#### **MEMORANDUM**

**OSDS Plans**

**1043 Thunderbird Drive**

The following comments pertain to the OSDS Plan for 1043 Thunderbird Drive:

SEPTIC SYSTEM INSTALLATION SITE PLAN

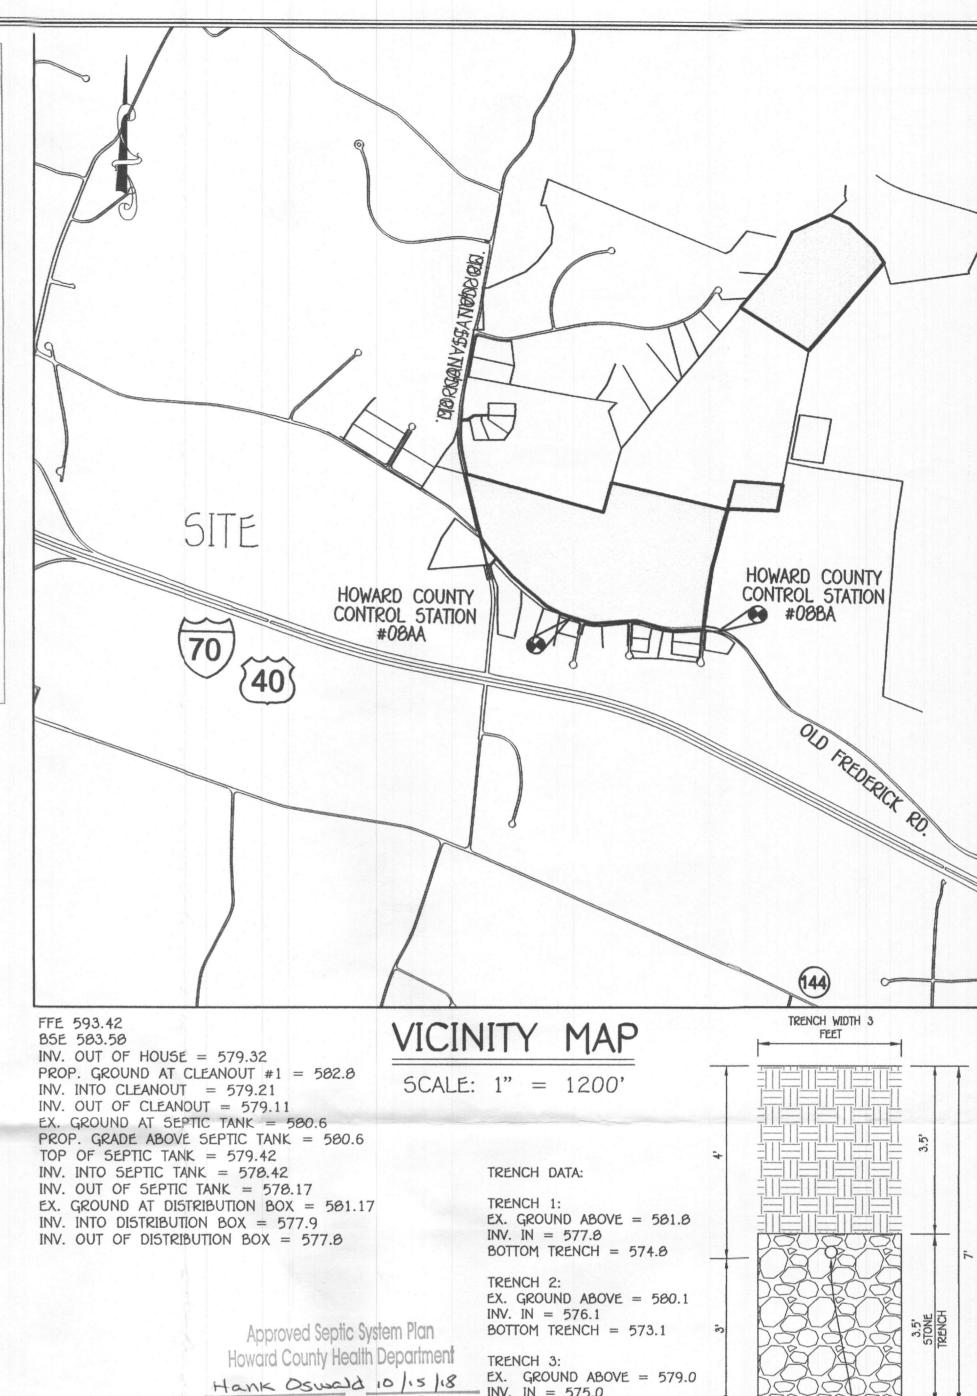
1. Correct bedroom count # in the initial system calculation.

2. Correct application rate #s in 1<sup>st</sup> and 2<sup>nd</sup> calculations (should be 1.2 not 0.8)

3. Proposed grade appears to come out below the basement. Is the septic profile correct?

> SEPTIC SYSTEM INSTALLATION SITE PLAN

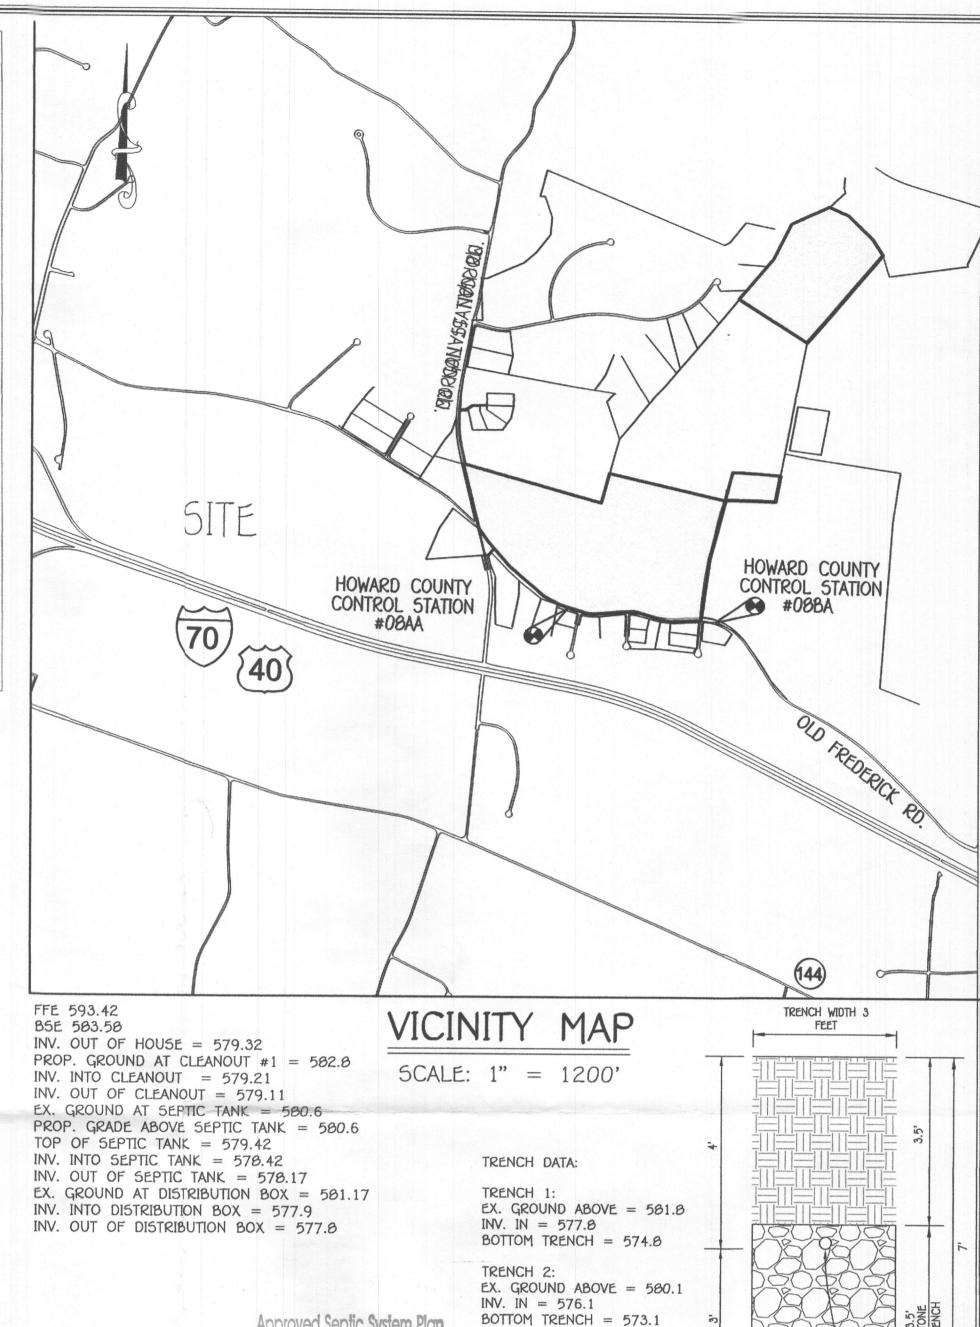
Good morning. Please revise the revised plan to show the correct application rates etc. according to the septic spec sheet (attached).
